North Coast Regional Water Quality Control Board

Name and Location of Facility Inspected Saggio Hills, 16840 Healdsburg Avenue Healdsburg, CA, 95448 Construction General Permit WDID #: 1 49C375878 App ID: 470857 CWA Section 401 Water Quality Certification WDID #: 1B06169WNSO		Inspection Date November 29, 2018	Inspection Time 1:00 pm-6:00 pm
Names & Titles of On-Site Representatives and Consultants Chris Theiss – The Robert Green Company Bob Keys – The Robert Green Company Clay Thistle – City of Healdsburg Curt Bates – City of Healdsburg Linda Ruffing – City of Healdsburg Steve Stenson – Advanced Stormwater Protection Kevin Kruizenga – Advanced Stormwater Protection Jim Fane – Carlile/Macy		Consent¹ Provided? Yes <input checked="" type="checkbox"/> No <input type="checkbox"/>	Notified of Inspection? Yes <input checked="" type="checkbox"/> No <input type="checkbox"/>
Regional Water Board Inspector Name & Title Heidi M. Bauer - Engineering Geologist, P.G. Paul Nelson - Engineering Geologist, P.G., C.Hg. Josh Luders - Water Resources Control Engineer Jeremiah Puget - Senior. Environmental Scientist (Specialist) *Referred to as inspection team / staff

Figure 2. Regional Water Board Turbidity Sample Results.

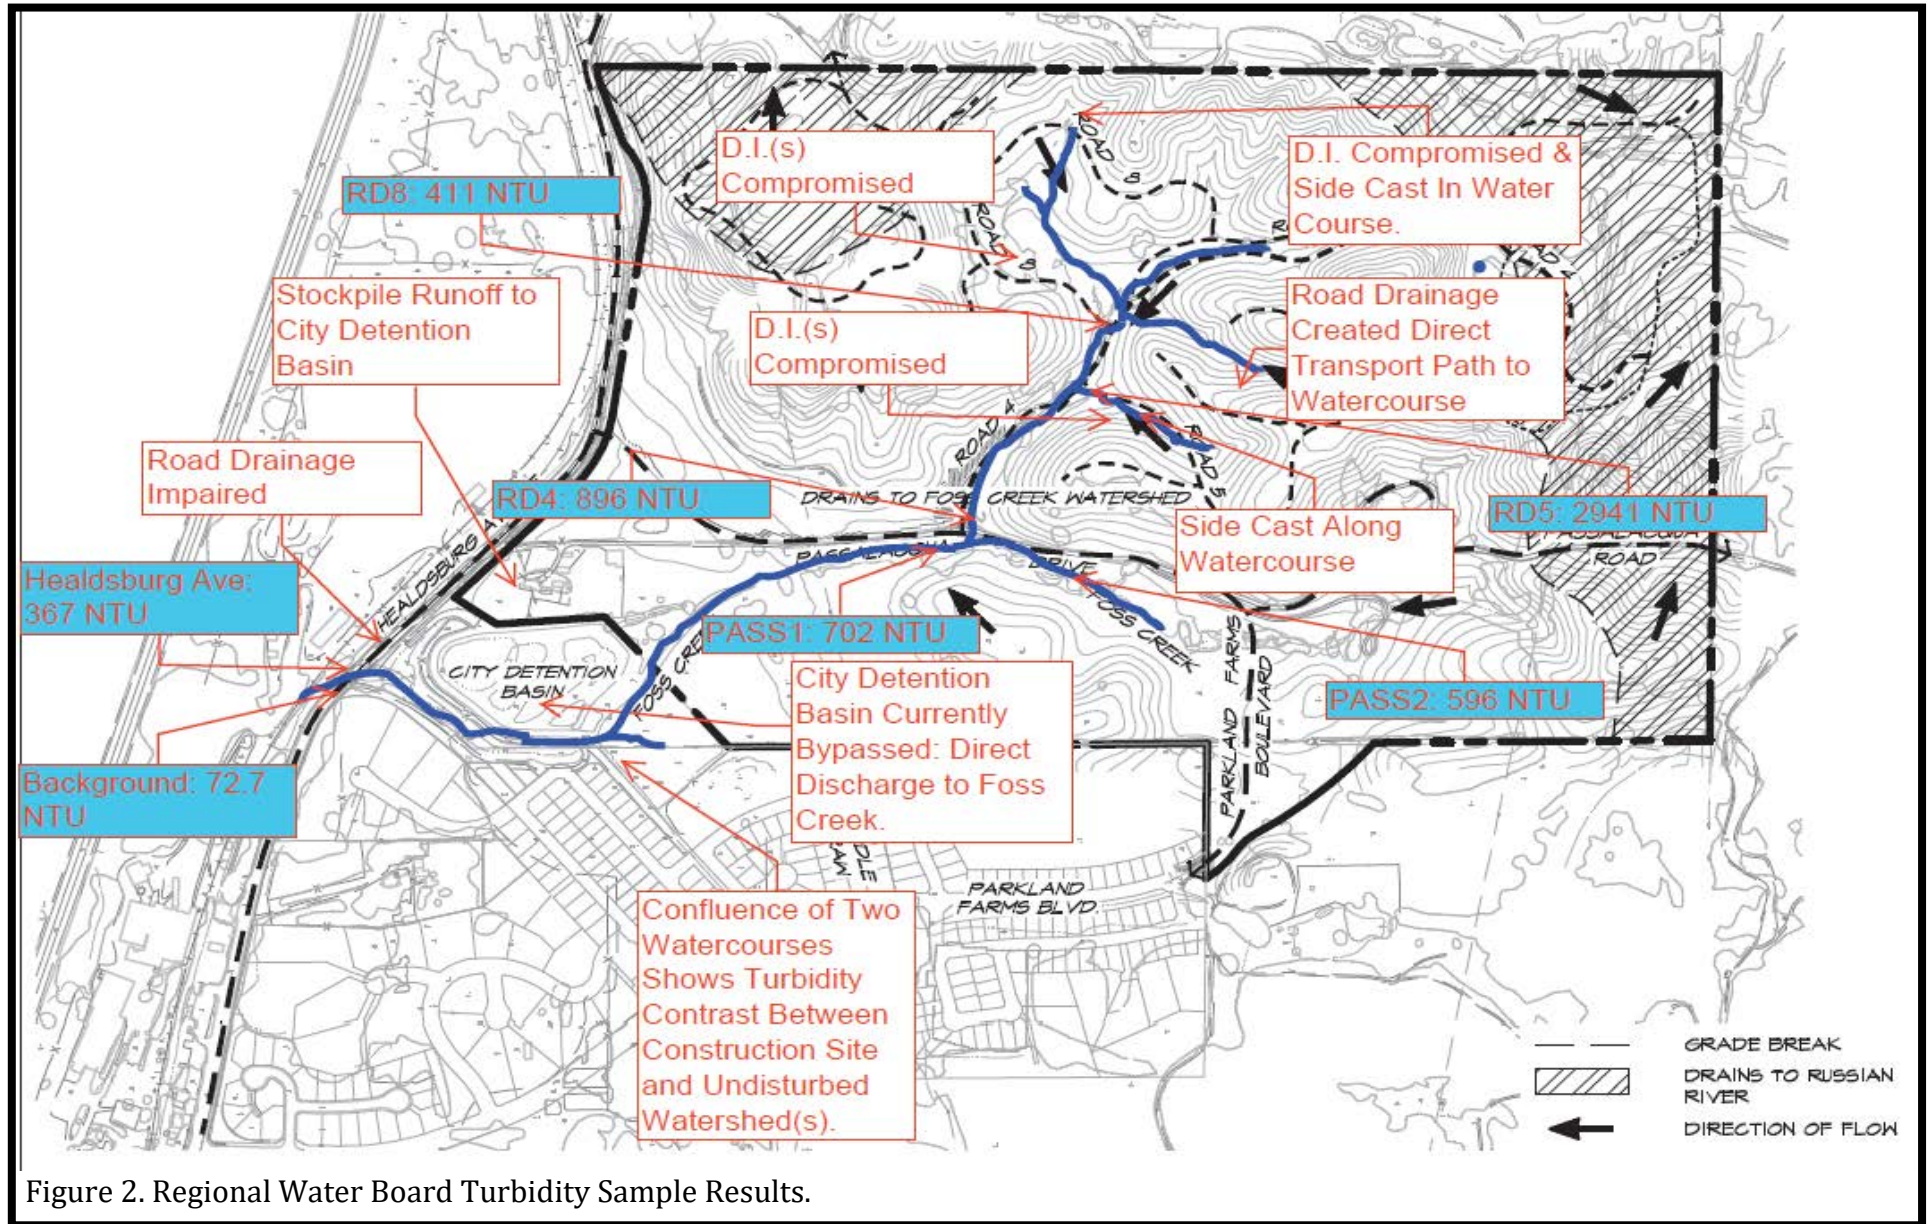
During the Site inspection Regional Water Board staff collected turbidity samples from seven locations as shown in Figure 2 below. The samples gathered were collected to assess upstream or background conditions to compare with downstream samples influenced by storm water effluent. Turbidity samples were analyzed by Regional Water Board staff in accordance with EPA Method 180.1.

Turbidity results ranged from 367 nephelometric turbidity units (NTU) to 2,941 NTU in samples collected from Healdsburg Ave. and Road 5 (RD5), respectively. As depicted in Figure 2, the most upstream sample RD8 was measured at 411 NTU, although this sample was influenced by storm water runoff from construction activities. Downstream sample RD4 was measured at 896 NTU a 118% percent increase as compared to sample RD8. The Basin Plan water quality objective for Turbidity states "Turbidity shall not be increased more than 20 percent above naturally occurring background levels." While it is acknowledged that sample RD8 was elevated above natural background levels it serves as an upstream background concentration and sample RD4 indicates an exceedance of the water quality objective.
